# UNITED STATES PATENT AND TRADEMARK OFFICE

APPLICATION NO.	FILING DATE	FIRST NAMED INVENTOR	ATTORNEY DOCKET NO.	CONFIRMATION NO.
10/538,284	06/29/2005	Ho Seob Kim	KIMH3005/REF	2017
23364	7590	07/03/2007		
BACON & THOMAS, PLLC 625 SLATERS LANE FOURTH FLOOR ALEXANDRIA, VA 22314			EXAMINER JOHNSTON, PHILLIP A	
			ART UNIT 2881	PAPER NUMBER
			MAIL DATE 07/03/2007	DELIVERY MODE PAPER

## Office Action Summary

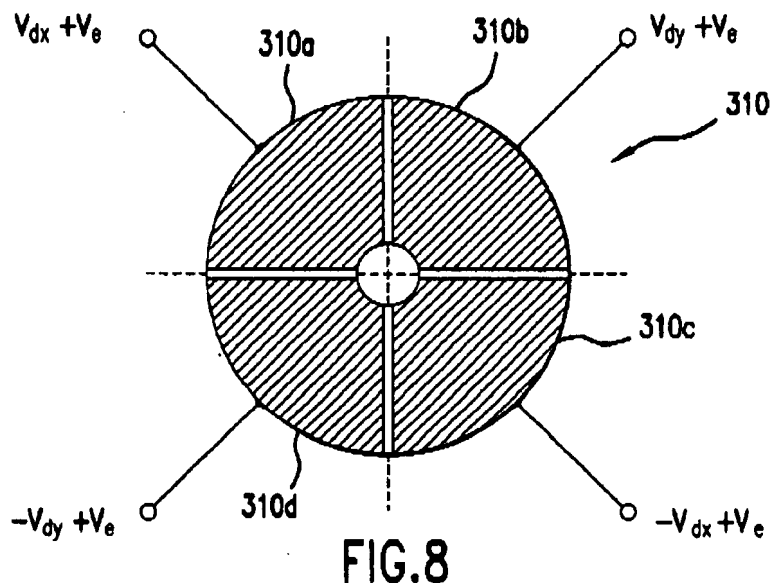
3. Regarding claim 1, Chang teaches centering extraction electrode 310 (note Figure 8 below) fabricated on a silicon substrate that includes four electrode elements 310a, 310b, 310c, and 310d (a plurality of sensing regions), which are separated by (divided by) insulating layers. Col. 5, line 6-18; and line 62-67.

FIG. 4

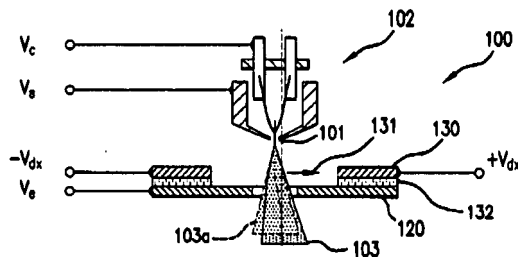
Chang also teaches that voltages ranging from a few tens of volts to a few hundred volts are applied to the extraction electrodes centering regions to correct for beam misalignment (note Figure 4 below). Col. 4, line 22-54.

It is implied in Chang above that, in order to define the voltage range applied to the extraction electrodes centering regions to keep the beam centered, one would have detected the beam striking the centering regions, or encountered misaligned emitters that produced off axis beams that struck the centering regions. However Chang fails to teach the electron beam striking the centering (sensing) regions.

FIG. 2a

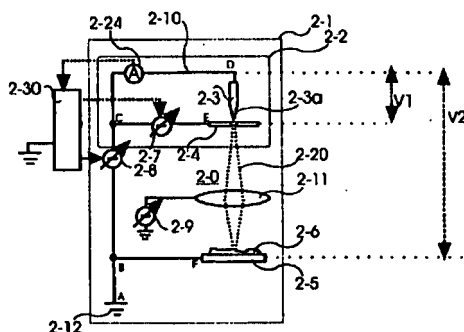
4. Winkler teaches an electron beam micro-column 2-1 (Note Figure 2a below) where an extractor electrode 2-4 is connected via conducting lines to current sensing unit 2-24 that measures the amount of beam current absorbed (striking) by the extraction electrode. See Col. 10, line 62-67; and Col. 11, line 1-7.

5. Winkler modifies Chang to provide sensing of the amount of beam current absorbed (striking) in the extractor electrode.

6. Therefore it would have been obvious to one of ordinary skill in the art that Chang would use the divided extraction electrode to sense a beam current striking the centering regions and deflect the beam back to ensure that the electron beam is aligned with the optical axis.
